STATE OF CONNECTICUT  
CONNECTICUT SITING COUNCIL

IN RE: :  
: :  
APPLICATION OF CELLCO PARTNERSHIP : DOCKET NO. 360  
D/B/A VERIZON WIRELESS FOR A :  
CERTIFICATE OF ENVIRONMENTAL :  
COMPATIBILITY AND PUBLIC NEED FOR :  
THE CONSTRUCTION, MAINTENANCE :  
AND OPERATION OF A WIRELESS :  
TELECOMMUNICATIONS FACILITY ON :  
PROPERTY OF THE FALLS VILLAGE :  
VOLUNTEER FIRE DEPARTMENT, INC., :  
188 ROUTE 7 SOUTH, FALLS VILLAGE, :  
CONNECTICUT : JUNE 16, 2008

RESPONSES OF CELLCO PARTNERSHIP D/B/A VERIZON WIRELESS  
TO CONNECTICUT SITING COUNCIL PRE-HEARING INTERROGATORIES

**Existing Verizon Wireless Cellular Coverage With Proposed Facility At 150 Feet AGL**  
 (\* Map Scale is 1:30,000)

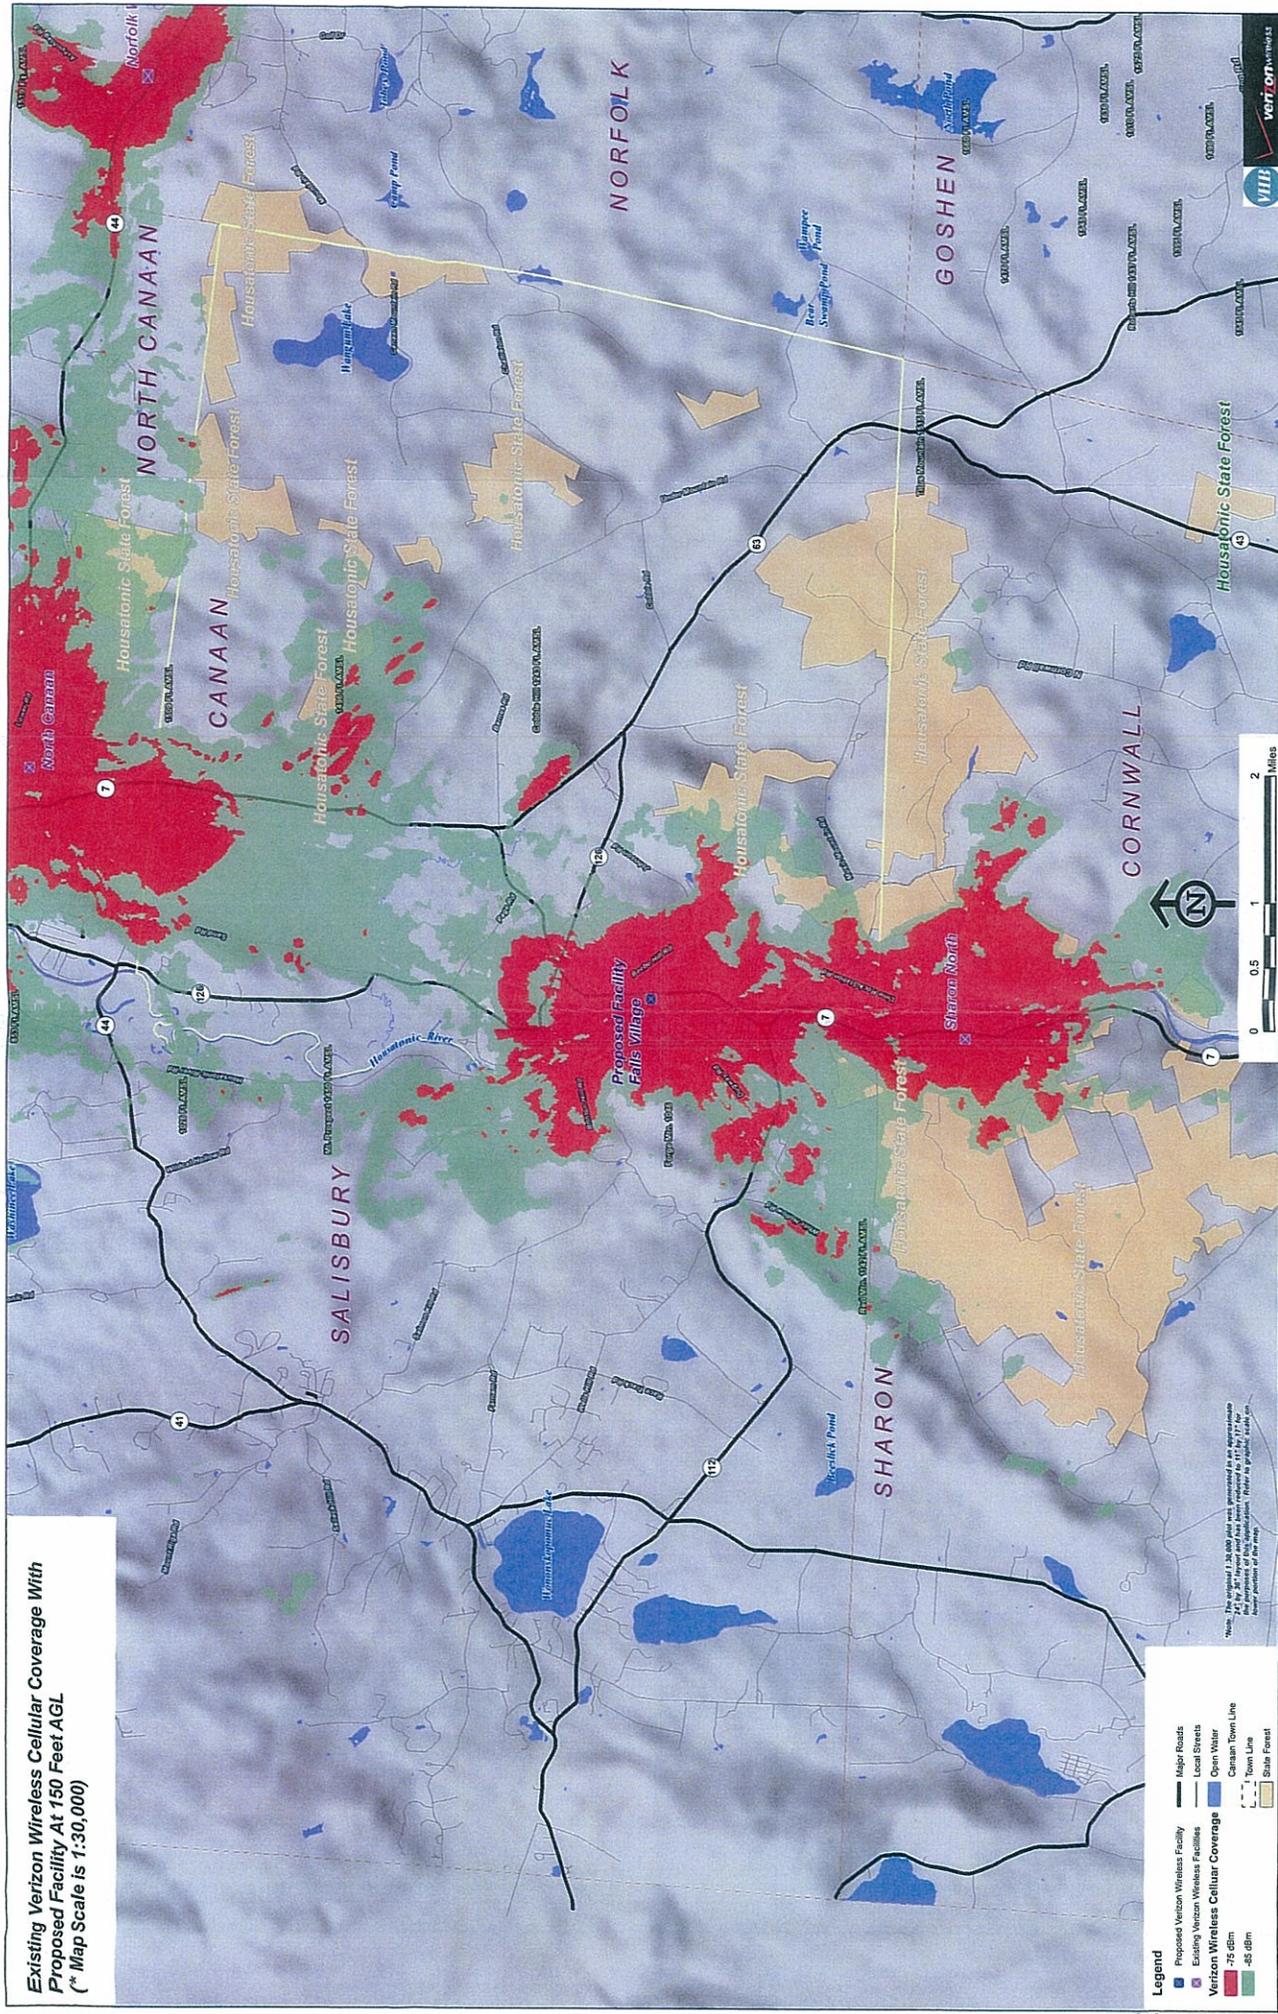
Would Cellco need an additional site to provide coverage north of the proposed site?

Yes. At both cellular and PCS frequencies, Cellco would need one additional facility to the north to provide continuous, reliable coverage along Route 7 between its existing North Canaan facility and the proposed Falls Village Facility. (See Application, Tab 7 – Coverage Plots showing existing and proposed PCS coverage and Coverage Plots behind Tab 1 of these responses showing existing and proposed cellular coverage in the Falls Village area).

Docket No. 360  
 Responses To Connecticut Siting Council Pre-Hearing Interrogatories  
 Question 28a  
 Existing Verizon Wireless PCS Coverage With  
 Proposed Facility At 140 Feet AGL  
 (Map Scale is 1:30,000)

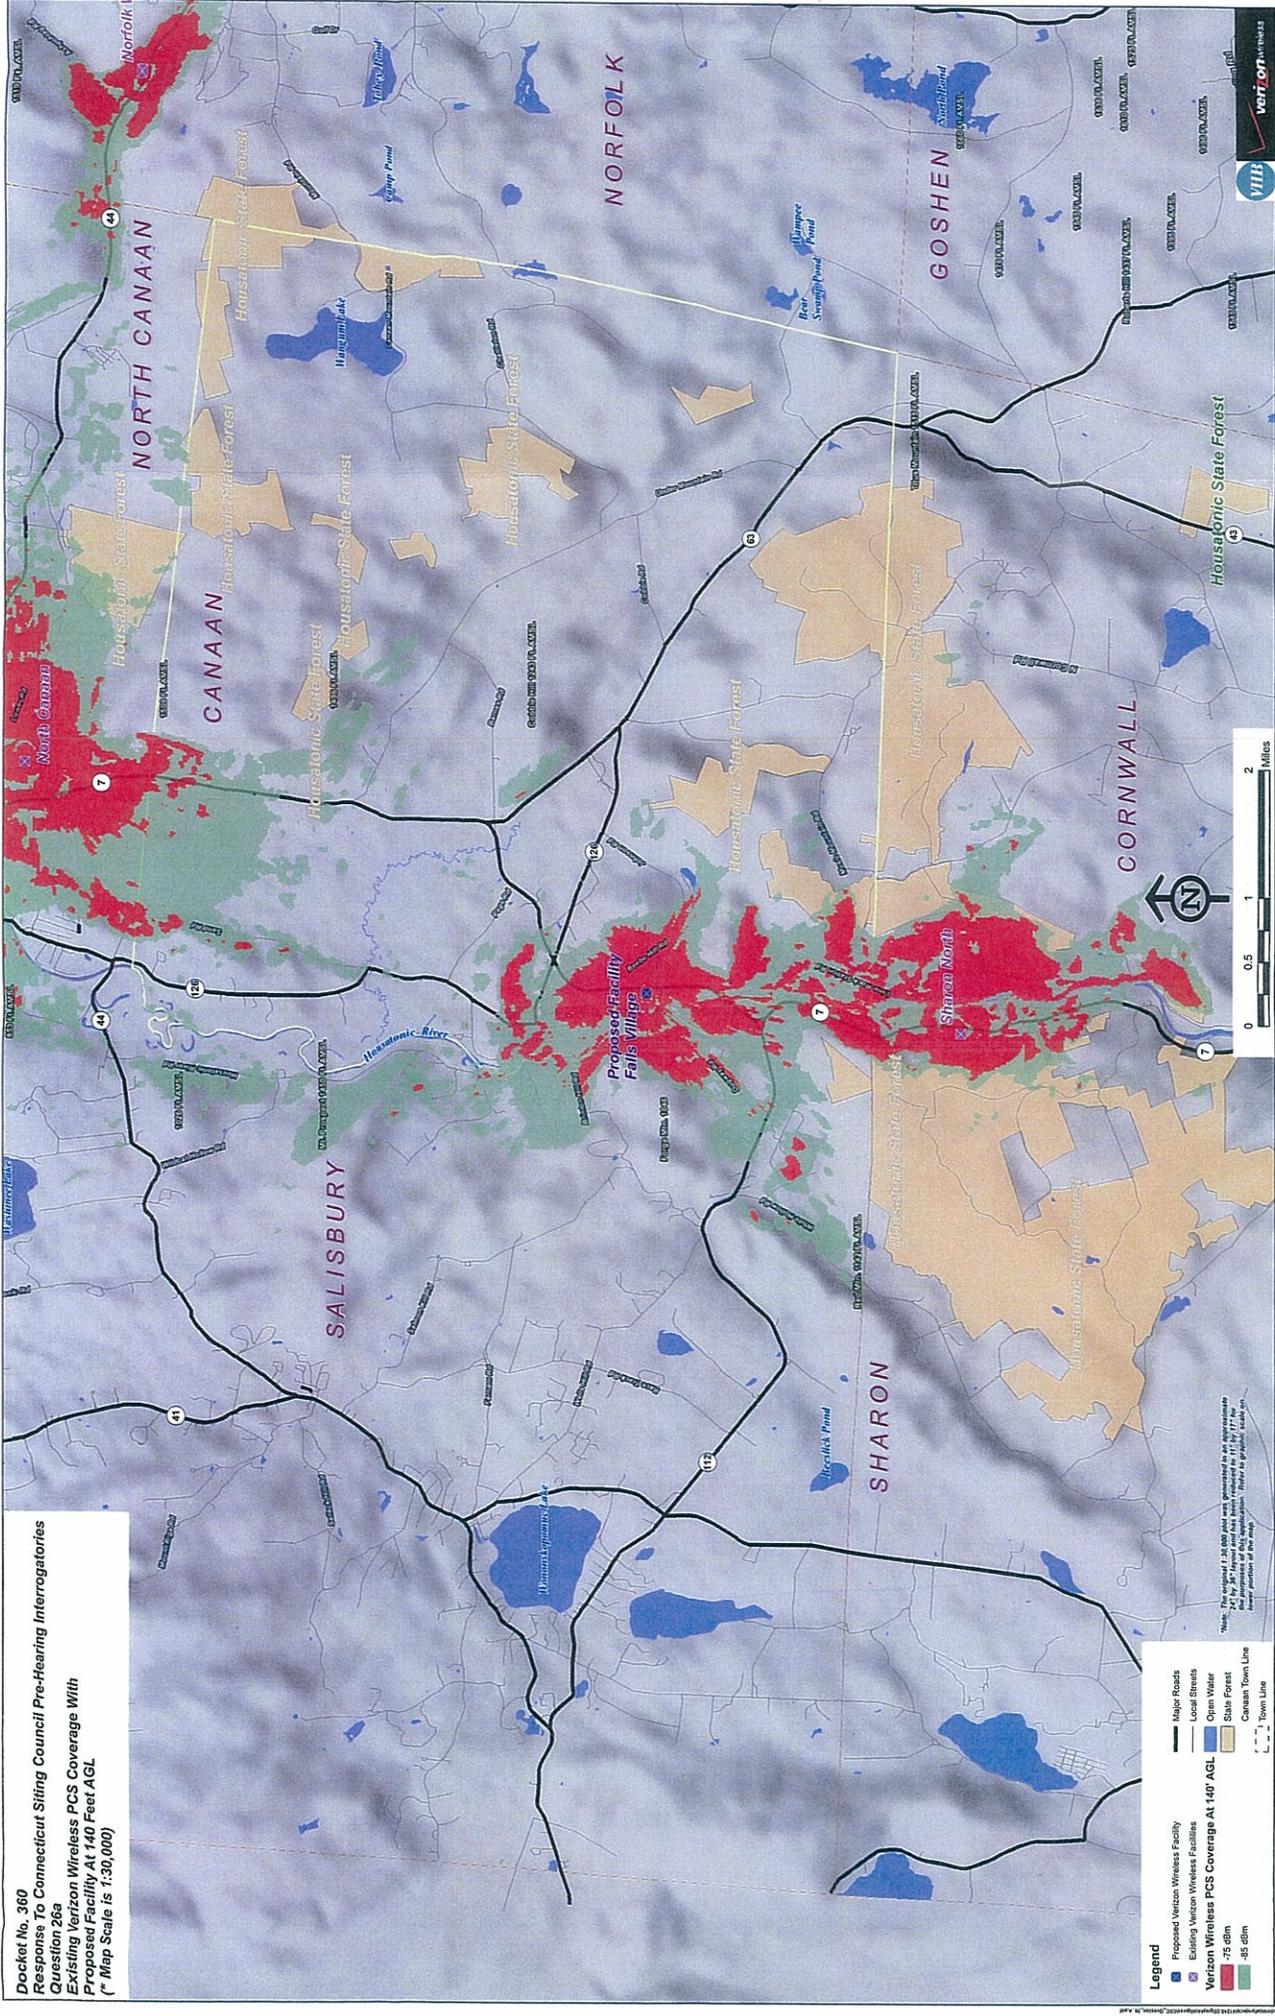
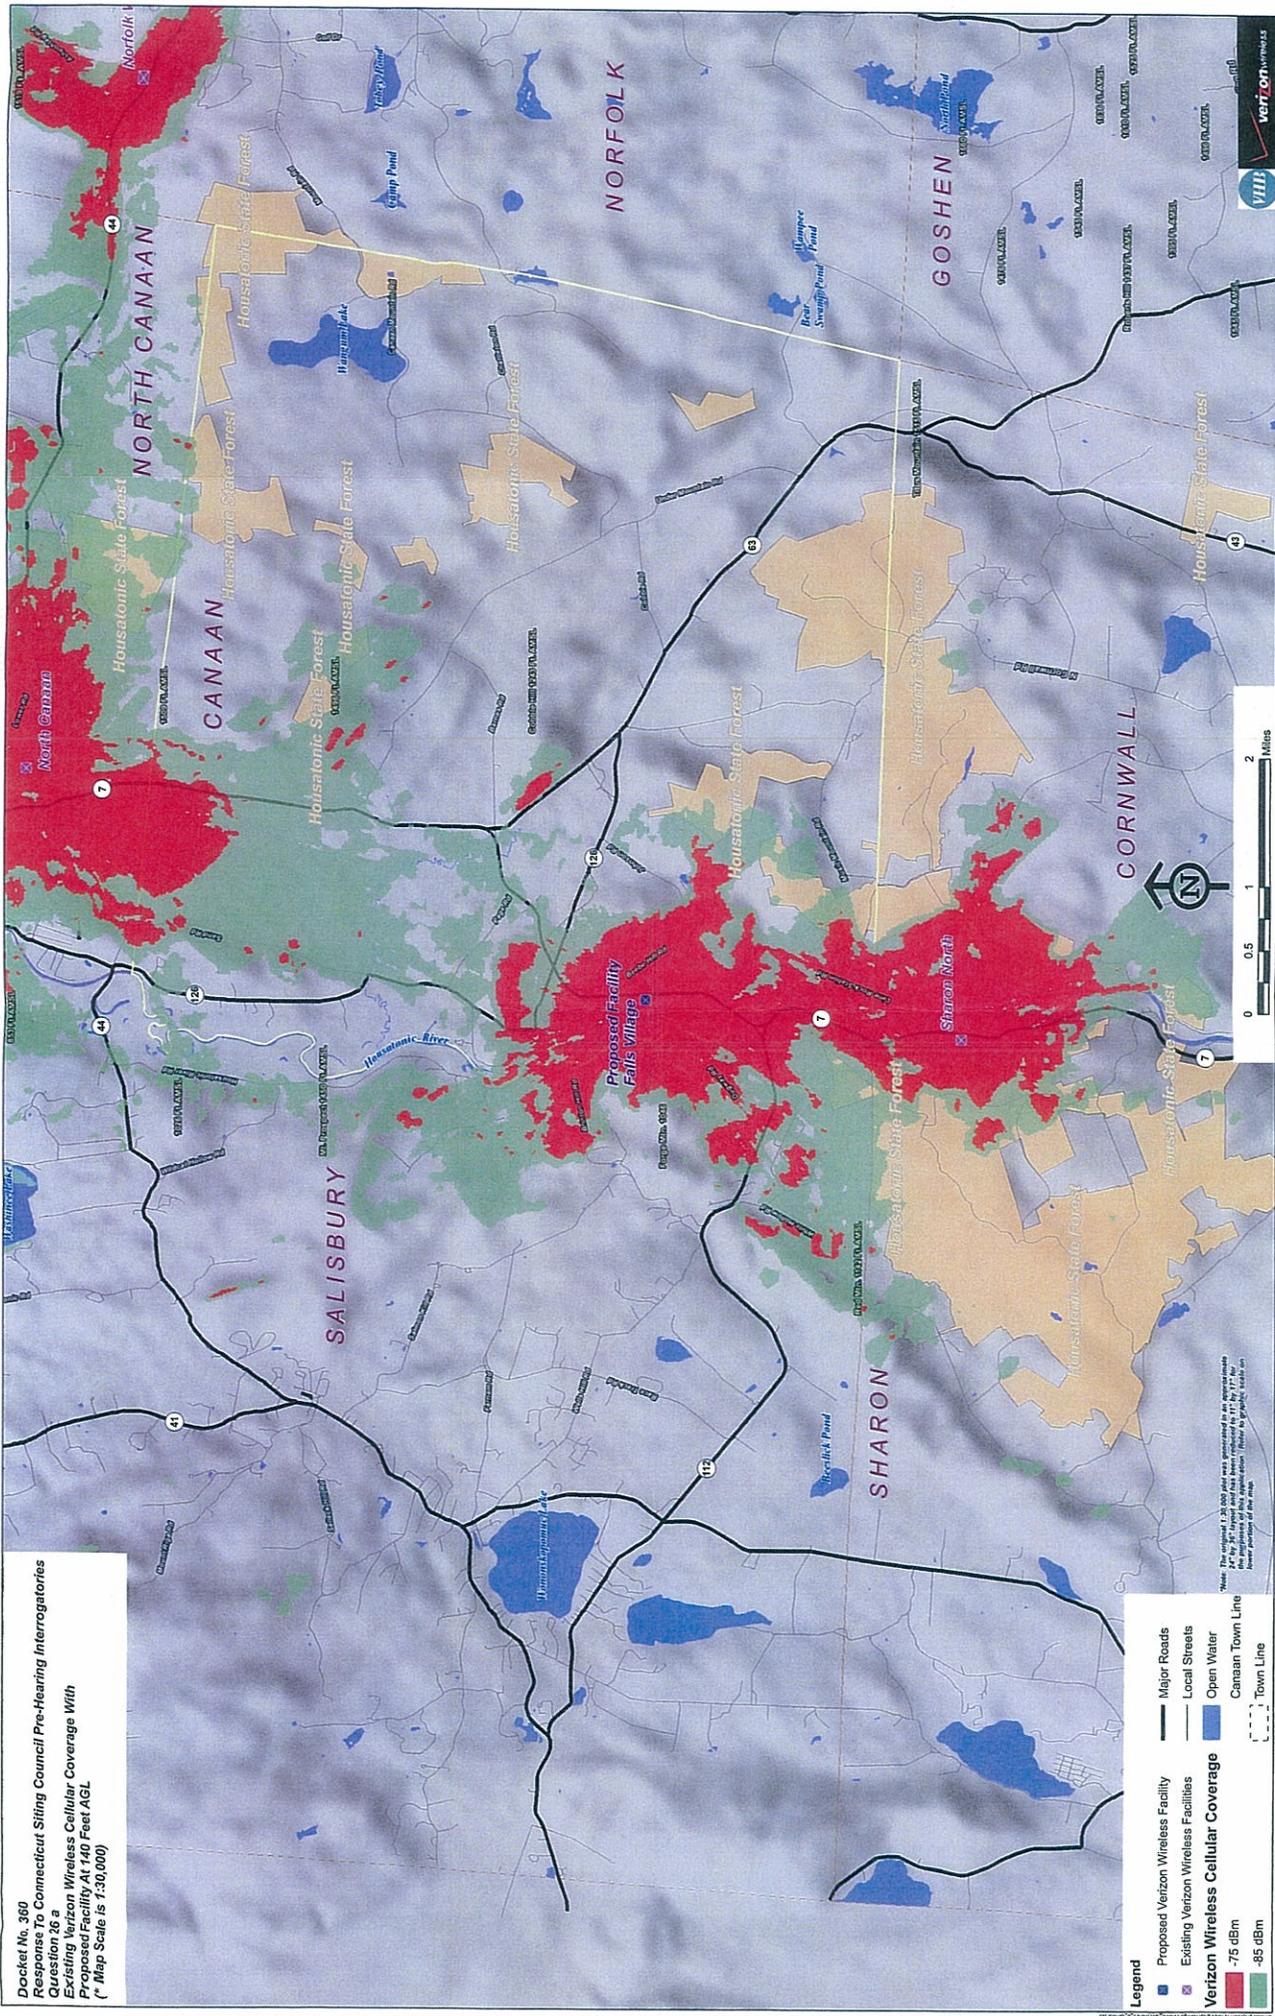
Provide a multi-signal level propagation plot (including the signal levels Cellco designs for), at a scale of 1:30,000, depicting coverage from the following:

- a) existing sites and proposed site at an antenna height of 140 feet above ground level.
- b) existing sites and proposed site at an antenna height of 130 feet above ground level.

As discussed above, Cellco has recently acquired and expects to deploy both PCS and cellular service at the proposed Falls Village Facility. Included behind Tab 2 of these responses are coverage plots depicting coverage from the proposed Falls Village Facility at the heights requested at both PCS and cellular frequencies.
